3/31/09	Added General Note (F)
DATE	REVISION	
STATE OF HAWAII DEPARTMENT OF TRANSPORTATION HIGHWAYS DIVISION BRIDGE GENERAL NOTES INTERSTATE ROUTE H-1 EXTENSION AND REPAIR OF SCHOOL STREET ON-RAMP RETAINING WALL Project No. H11-01-08 Scale: As Noted Date: Feb., 2009

3/31/09	Revised and/or Added Callouts and Legend
DATE	REVISION
STATE OF HAWAII DEPARTMENT OF TRANSPORTATION HIGHWAYS DIVISION RETAINING WALL REPAIR and EXTENSION EXISTING SITE PLAN INTERSTATE ROUTE H-1 EXTENSION and REPAIR of SCHOOL STREET ON-RAMP RETAINING WALL Project No. H11-01-08	
Scale: As Noted	Date: Feb, 2009
SHEET No. Q3 OF 34 SHEETS

RETAINING WALL REPAIR and EXTENSION

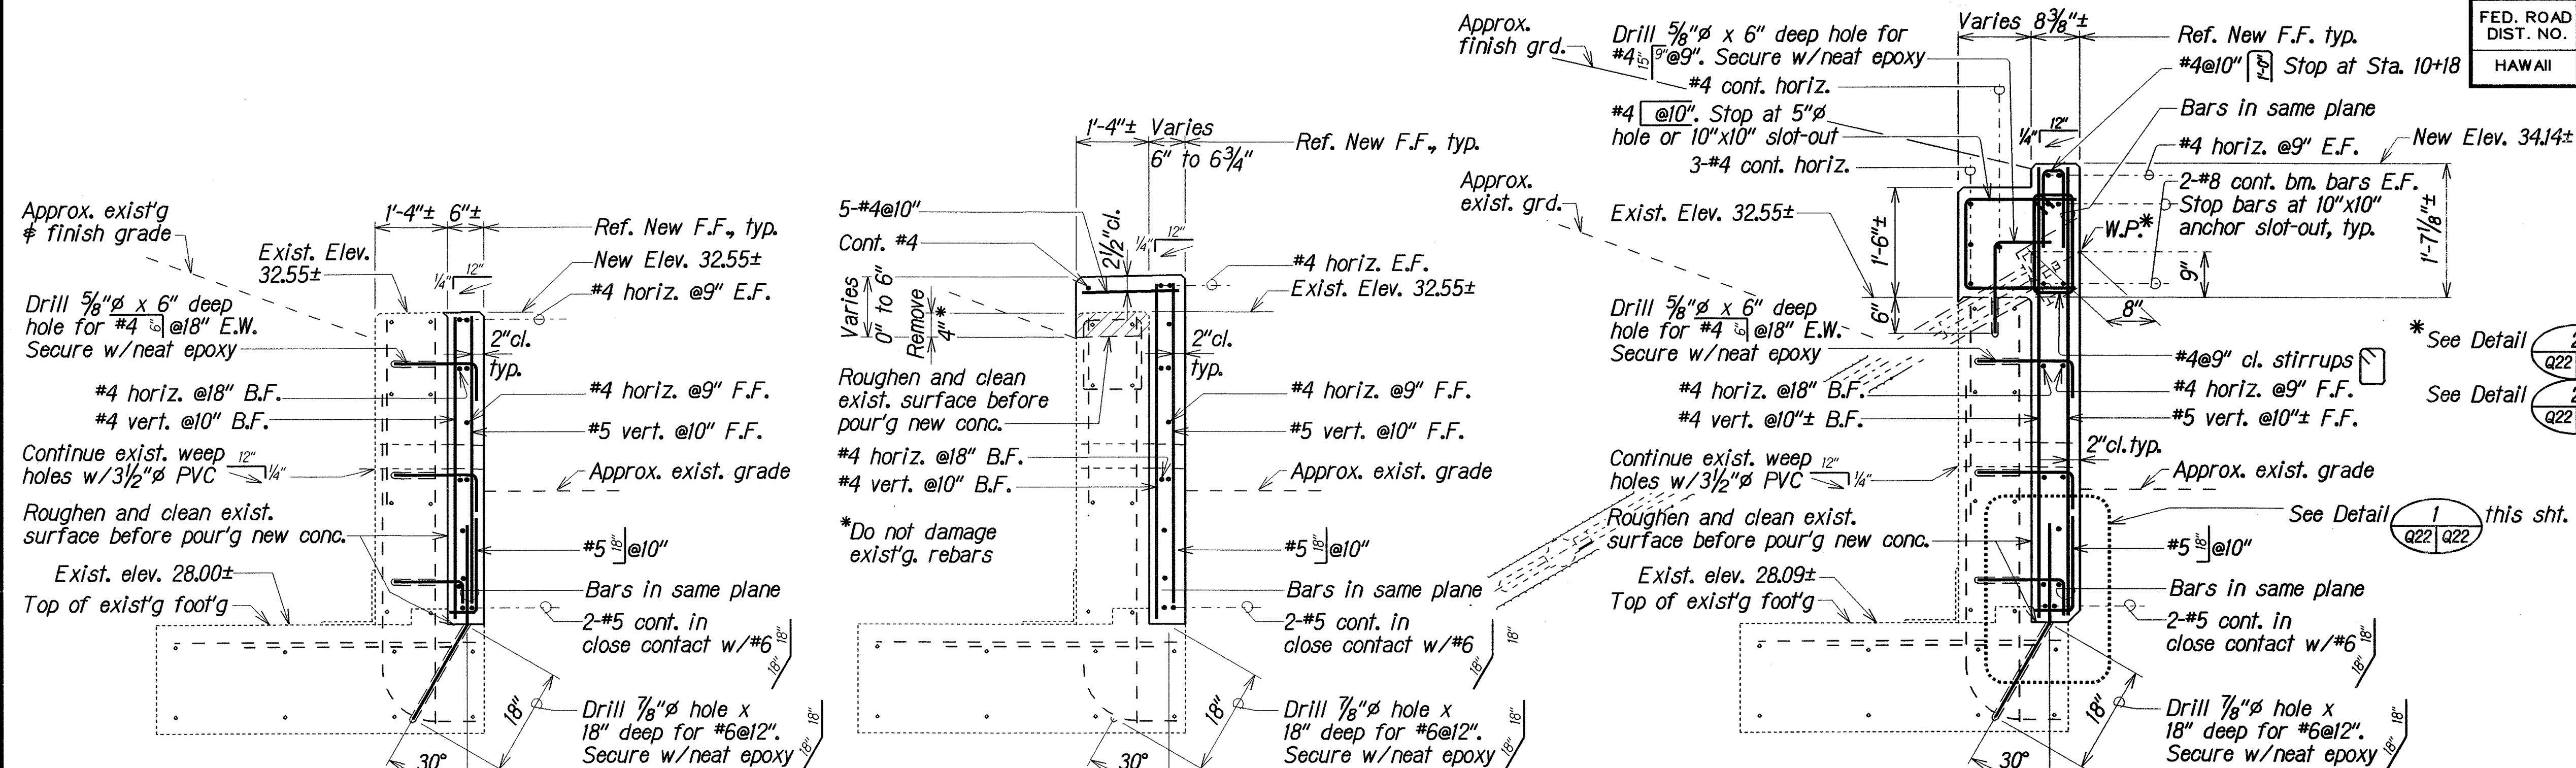
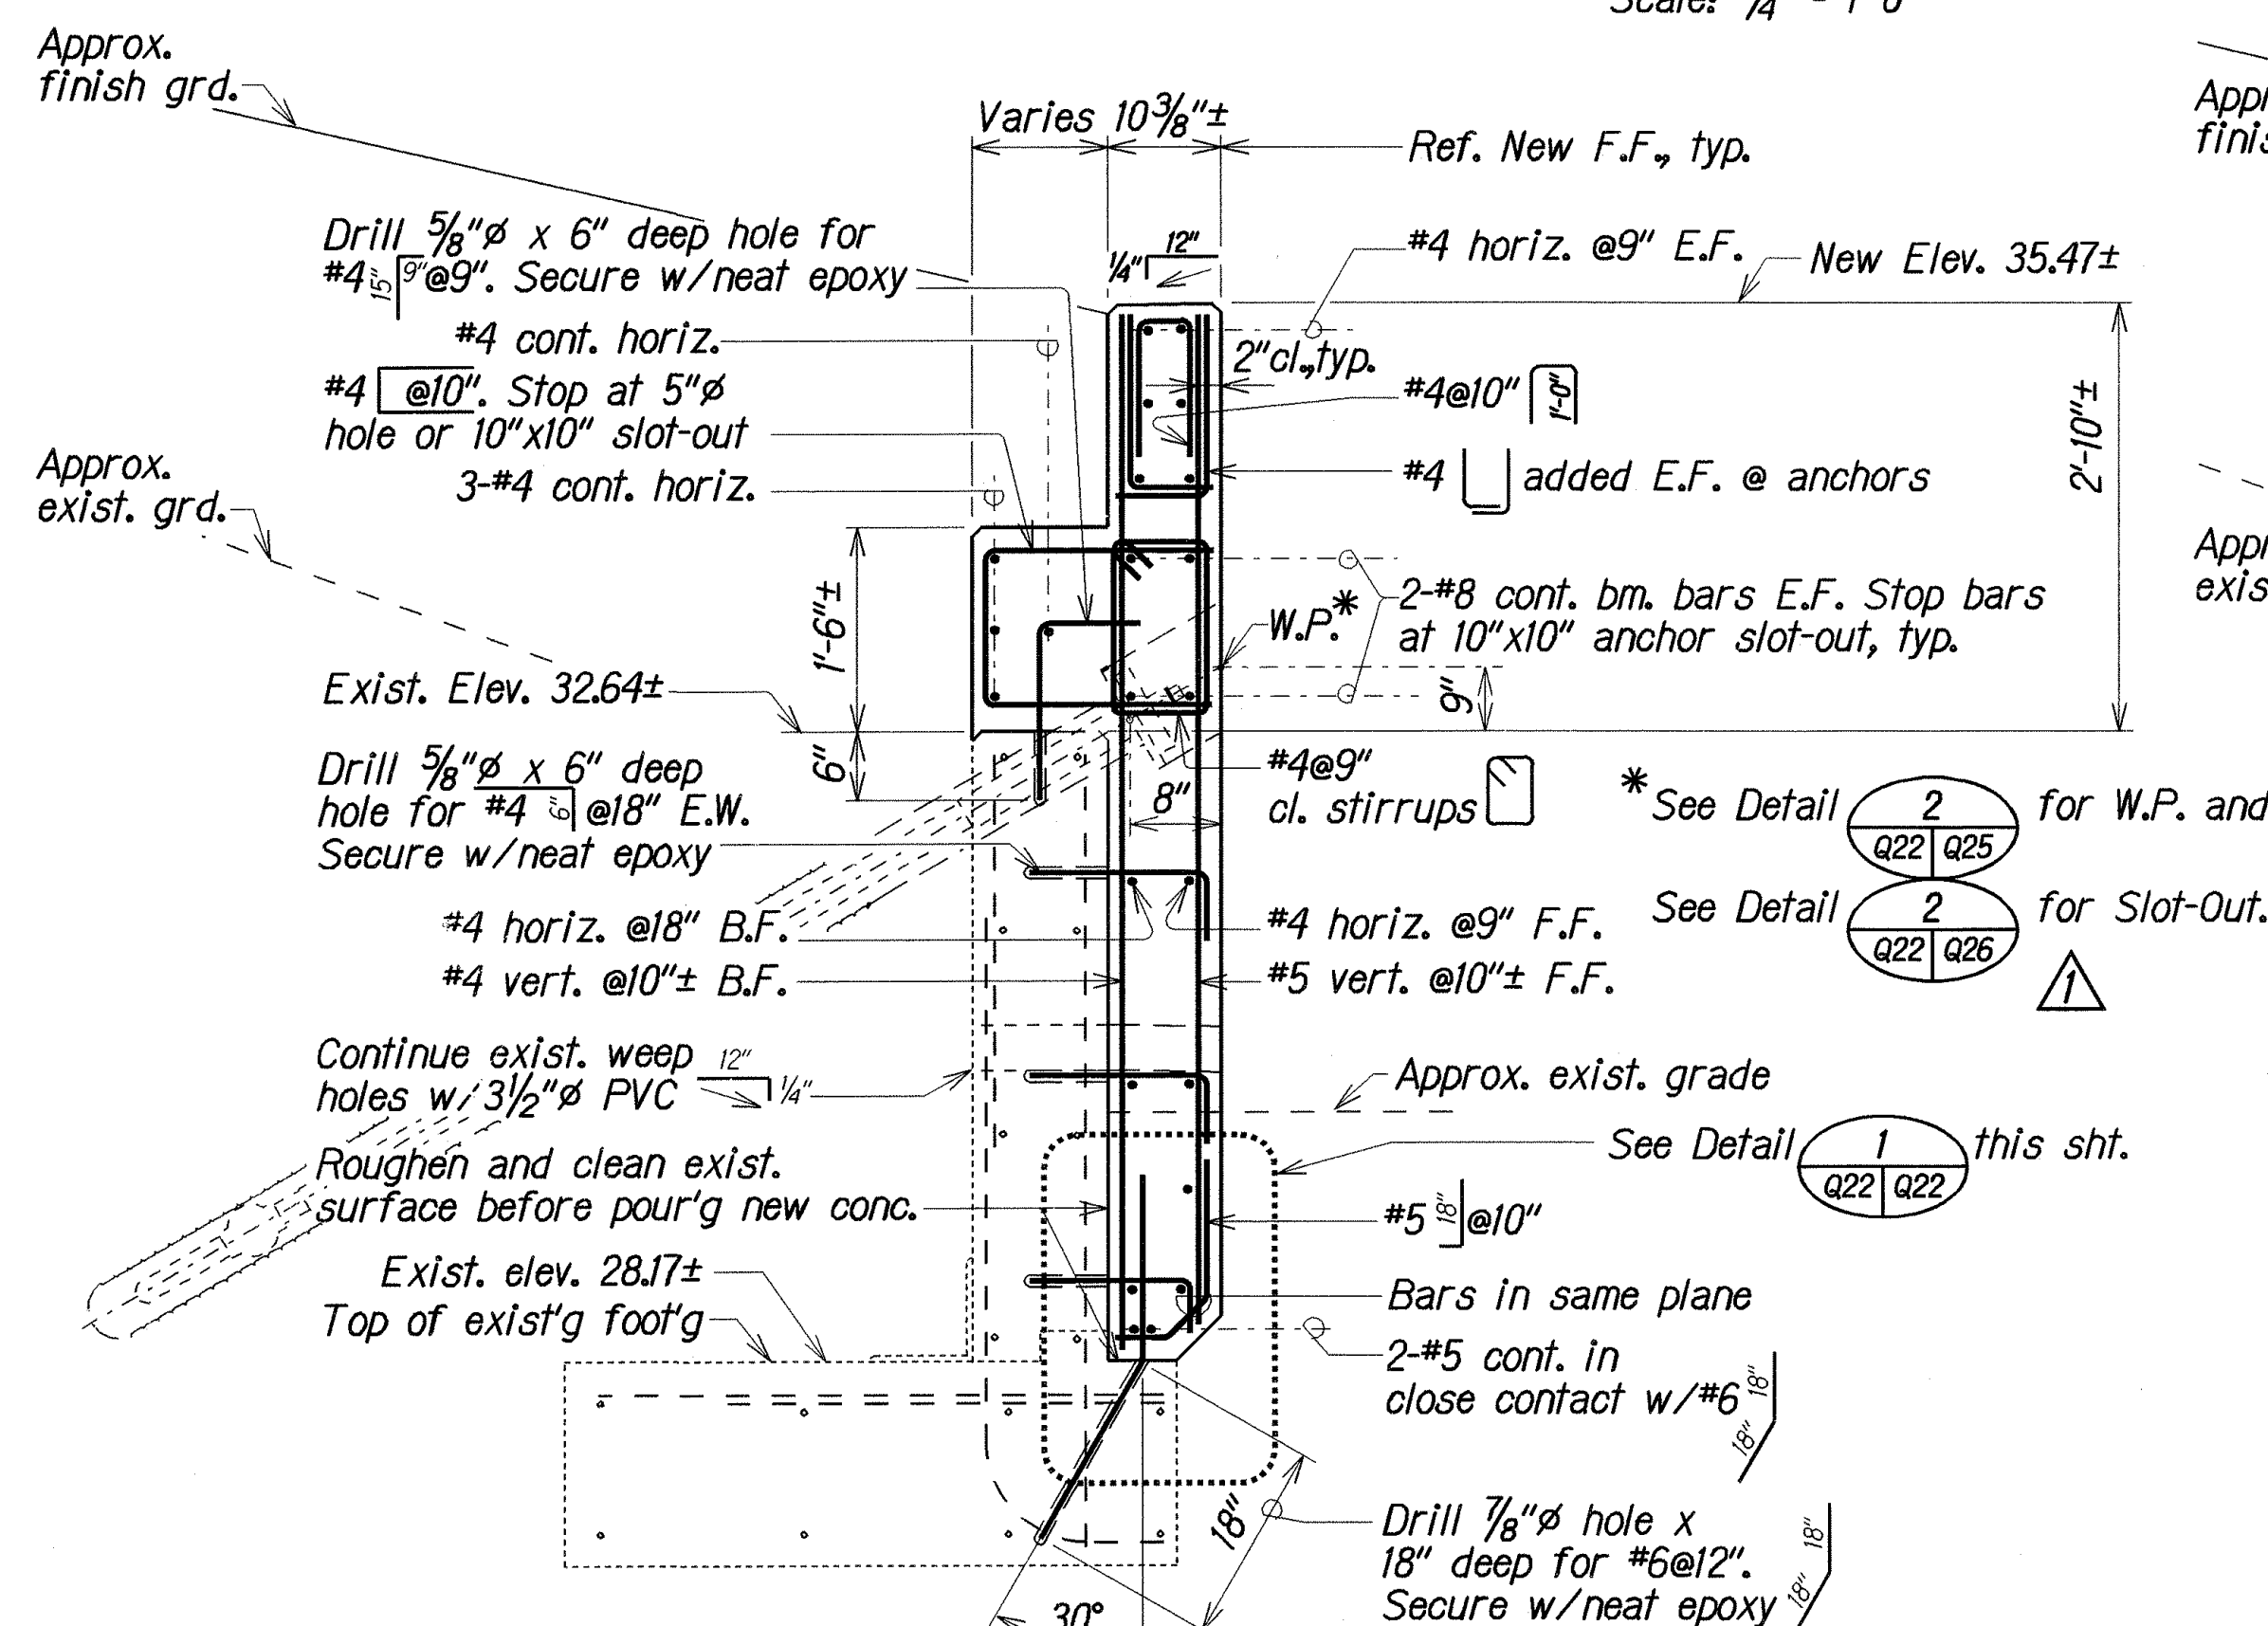
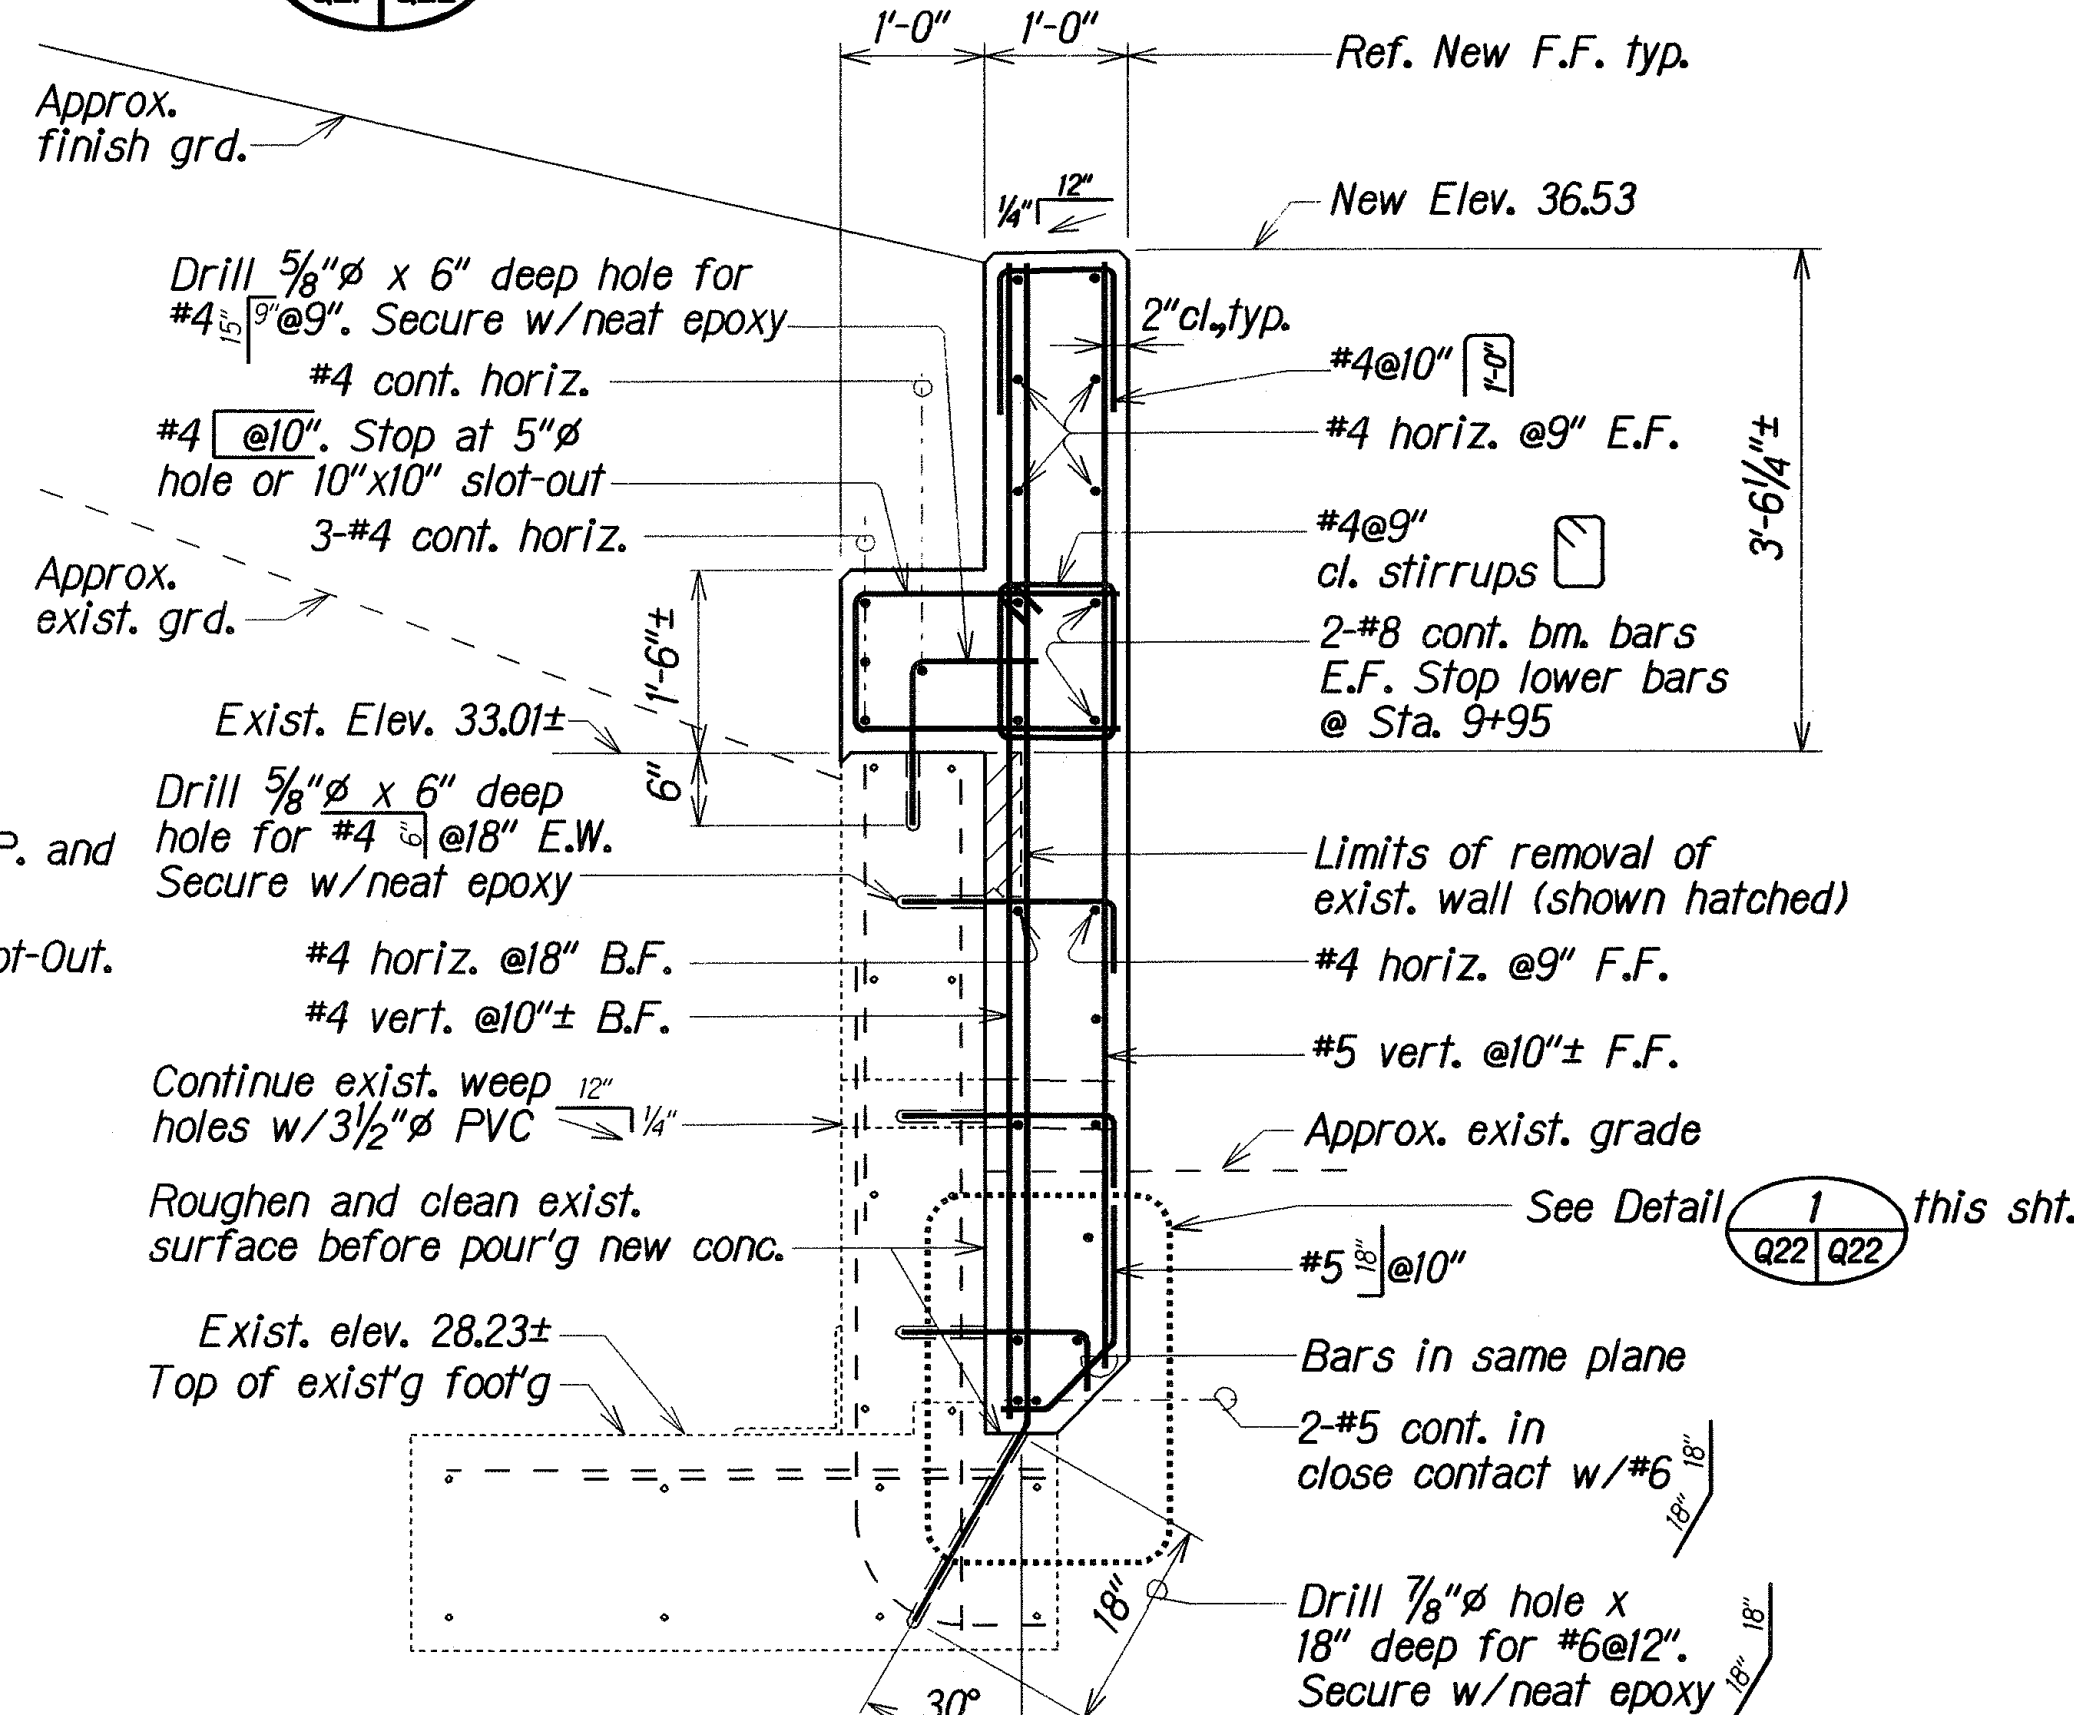
Added Detail Symbol and Section	HA Q21/Q22
DATE	DESCRIPTION
3/31/09	STATE OF HAWAII DEPARTMENT OF TRANSPORTATION HIGHWAYS DIVISION RETAINING WALL REPAIR WALL "P" SECTIONS INTERSTATE ROUTE H-1 EXTENSION AND REPAIR OF SCHOOL STREET ON-RAMP RETAINING WALL Project No. H11-01-08
Scale: As Noted	Date: Feb. 2009
SHEET No. Q22 OF 34 SHEETS
